# KENWOOD

## SERVICE BULLETIN

SUBJECT  
TS-930S AUDIO OSCILLATION

DATE  
8-16-83

Schematic

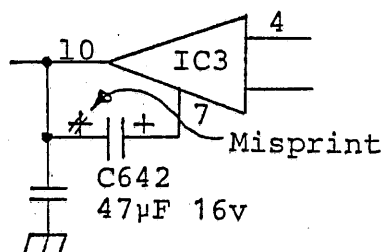
Some users have reported an audio oscillation when the AF gain control is set between 10:00 and 12:00.

The cause may be that Signal Unit (X57-1000-XX) capacitor C642 is installed backwards. See figures below. Please change your service manual schematic to reflect the correct positioning when you check the board.

Note: This change is applicable to units before S/N 307XXXX.
